**ZONING AMENDMENT,
PLANNED UNIT DEVELOPMENT &
SUBDIVISION STAFF REPORT**

Date: October 21, 2010

<u>NAME</u>	Douglas Roy Parker, III
<u>SUBDIVISION NAME</u>	South Jones Subdivision
<u>LOCATION</u>	1926 & 2000 Telegraph Road (Southeast corner of Telegraph Road and New Bay Bridge Road.)
<u>CITY COUNCIL DISTRICT</u>	District 2
<u>PRESENT ZONING</u>	B-2, Neighborhood Business District, and I-1 Light Industry District
<u>PROPOSED ZONING</u>	I-1, Light Industry District
<u>REASON FOR REZONING</u>	To eliminate split zoning to allow the expansion of a welding shop in phases.
<u>AREA OF PROPERTY</u>	2 Lots / 3.4 Acres ±
<u>CONTEMPLATED USE</u>	<p>Subdivision approval to create 2 legal lots of record, Planned Unit Development Approval to allow multiple buildings on a single building site as well as shared access and parking between two building sites, and Rezoning from B-2, Neighborhood Business District, and I-1 Light Industry District, to I-1, Light Industry District, to eliminate split zoning and allow for the expansion of a welding shop in phases.</p> <p>It should be noted, however, that any use permitted in the proposed district would be allowed at this location if the zoning is chang

SITE PLAN

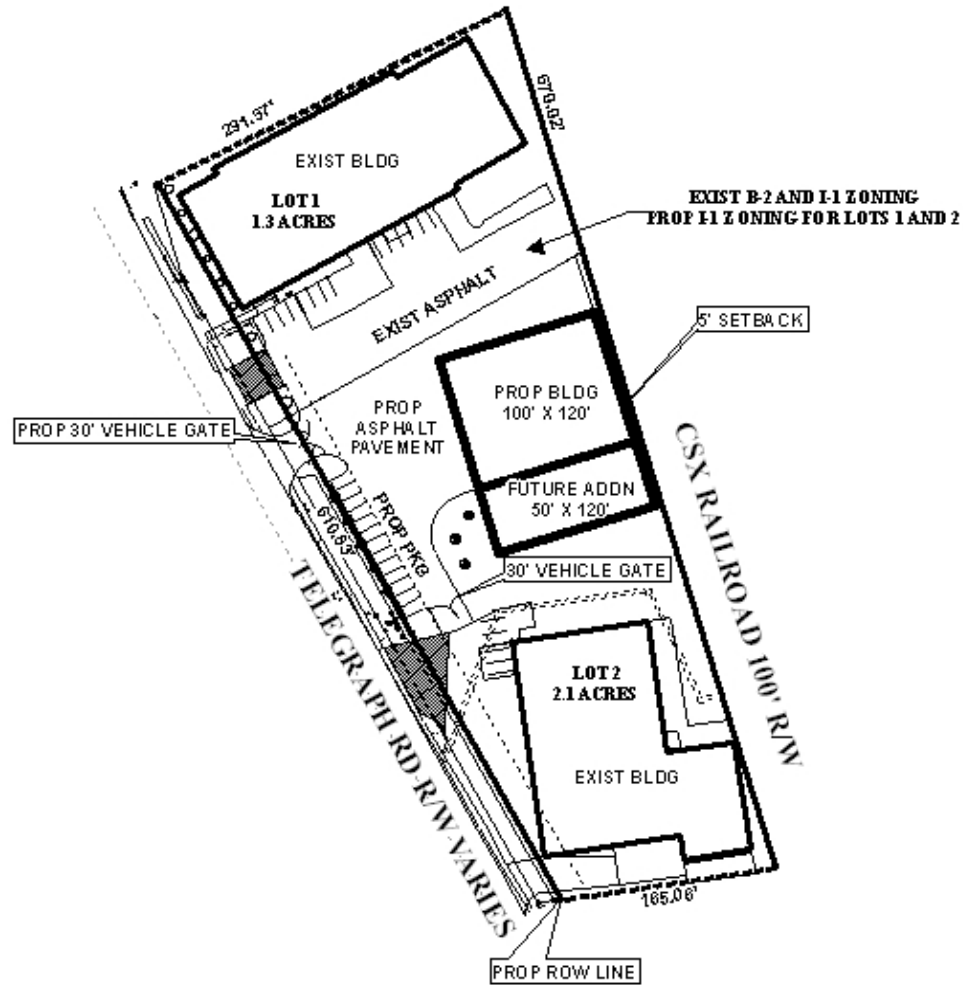
There are several deficiencies with the site plan that has been submitted. Regarding the existing development on the site, the site plan does not appear to depict the entirety of the paved area for maneuvering on the site. The site plan should be revised to depict all areas which are paved, or proposed to be paved. The site plan indicates existing and proposed curb cuts, including the large, continuous curb cut at 1926 Telegraph Road. Also indicated is a new vehicle gate at the proposed new curb cut. The site plan does not indicate whether the gate also includes a fence, and whether or not any of the other curb cuts will be gated. Additionally, gated access requires 51 feet of queuing area for vehicle stack-up. The site plan should be revised to address these issues.

Regarding the Southernmost two curb cuts, one is approximately 55 feet wide and the other is approximately 130 feet wide with only a small 30-foot wide break between them. It should be noted that it appears that this situation developed without benefit of approvals, and required landscaping was removed improperly. This situation should be remedied reducing the curb cuts to two standard 24-foot width cuts. Also, as mentioned previously, information should be provided to indicate whether or not these curb cuts will be gated.

The site plan contradicts itself regarding parking. The site plan indicates that 17 parking spaces will be provided, however, 32 parking spaces are depicted. This discrepancy should be corrected, and all parking spaces that will remain should be indicated as such on the site plan.

Dumpsters are not indicated on the site plan. The location of all dumpsters, with dumpster/recycle pads, appropriate enclosures, and appropriate amenity hookups should be depicted on the site plan. Any fencing on the site, regardless of type, should be indicated.

As mentioned earlier, it appears that landscaping area and tree plantings were improperly removed on the southernmost portion of the site. This situation should be resolved by bringing that portion of the site back into compliance. The new building area must meet full compliance with landscaping area and tree planting requirements of the ordinance as it represents at least a 50% expansion. Additionally, it has been the policy of the Commission to require full compliance with landscaping areas and tree plantings for the entire site that is included in the PUD. Since the two building sites will essentially function as one, full compliance for both sites should be required, and the site plan should be revised to indicate this.

As Telegraph Road is a planned major street, access management is a concern. The PUD proposes four curb cuts for the site, including the previously mentions 55-foot and 130-foot wide curb cuts. Given the proposed layout of the site, two curb cuts for the entire site should be sufficient. As the site will function as a PUD, the curb cuts should not be limited to specific lots, but shared between the two lots. The size, design, and exact location of all curb cuts are to be approved by Traffic Engineering and conform to AASHTO standards.

- 1) depict the entirety of the paved area for maneuvering on the site, including the boundaries of all paved areas;
- 2) revise the site plan to depict location of all proposed fencing and gates;

- 3) where gates will be installed at curb cuts, indicate 51 feet of queuing space between the right-of-way and the gate;
- 4) revise the site plan to indicate two shared curb cuts to the site with the size, location, and design to be approved by Traffic Engineering and conform to AASHTO standards;

- 5) revise the parking data to match what is shown on the site plan;
- 6) clearly indicate parking areas, number of spaces, and maneuvering areas;
- 7) indicate location of dumpsters on the site with appropriate dumpster pads and enclosures;

- 8) indicate full compliance for the entire site with tree planting and landscaping area requirements for the entire site; and
- 9) revise the site plan as appropriate to account for dedications which may be required by the subdivision application.

The applicant has submitted a revised site plan and a revised plat. The site plan depicts the changes that were requested.

Regarding the gate at the northern curb cut, the gate is depicted without adequate queuing space, however, there is no gate at the southern curb cut, and the secure area of the site can be reached through a gate with an appropriate amount of queuing space from that curb cut. The applicant has also indicated that they are willing to leave the gate at the northern curb cut open during business hours, and as such, a note should be placed on the site plan indicating such.

- 1) *placement of a note on the site plan stating that the gate for the northern curb cut will remain open during business hours;*
- 2) *full compliance with tree planting and landscaping requirements to be coordinated with Urban Forestry;*
- 3) *provision of two copies of the revised site plan to the Planning Section of the Urban Development Department prior to the issuance of any permits; and*
- 4) *full compliance with all municipal codes and ordinances.*
